PCN#20250608003.2

**Qualification of CDAT as an additional Assembly/Test site for the Select Devices
Change Notification / Sample Request**

Date: June 09, 2025

Sample product shipping label (not actual product label)

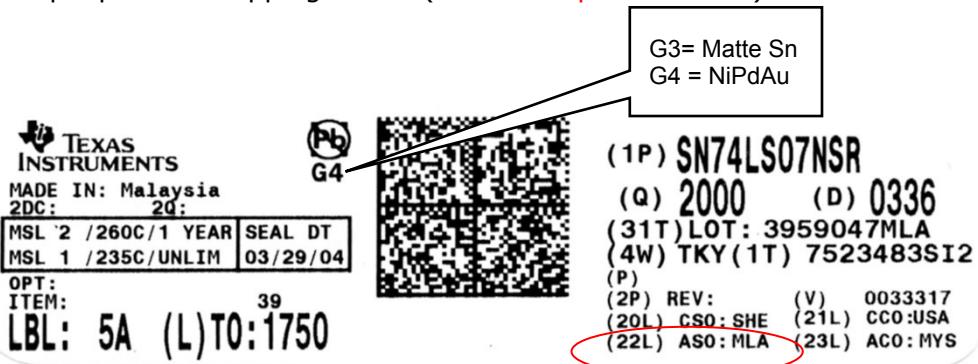
Changes to product identification resulting from this PCN:

Assembly Site	Assembly Site Origin (22L)	Assembly Country Code (23L)	Assembly City
TFME	NFM	CHN	Economic Development Zone
CDAT	CDA	CHN	Chengdu
